Wilson Arch Water & Sewer Special Service District PO Box 97 La Sal, UT. 84530

May 20, 2025

Thank you for the updated proposal for developing Lots H & I. The following response is based on the WILSON ARCH WATER AND SEWER SPECIAL SERVICE DISTRICT (WASSD) CULINARY WATER SYSTEM MASTER PLAN of 2022, water source and capacity findings from the Rural Water Association of Utah (RWAU), the mission of Wilson Arch Water & Sewer Special Service District Policies and Procedures, the placement of Well 4, and the placement of Large Underground Wastewater Disposal (LUWD) systems.

#### 4.3 PROJECTED REQUIRED SOURCE CAPACITY

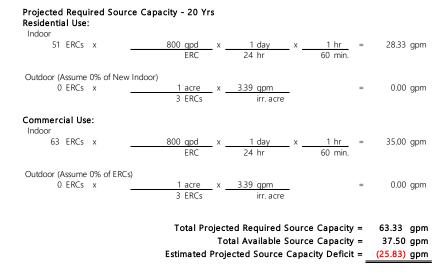
Note that in 2036, the Master Plan predicts the need of a fourth well for source water as there would be a 25.83 gpm deficit. The recent RWAU calculations showed a 20 gpm deficit.

The calculation above shows that Wilson Arch SSD has a 20-year projected source capacity deficit of 25.83 gpm. Wilson Arch SSD's projected source capacity requirement over the 20-year planning period is shown below in Figure 4.3.1.
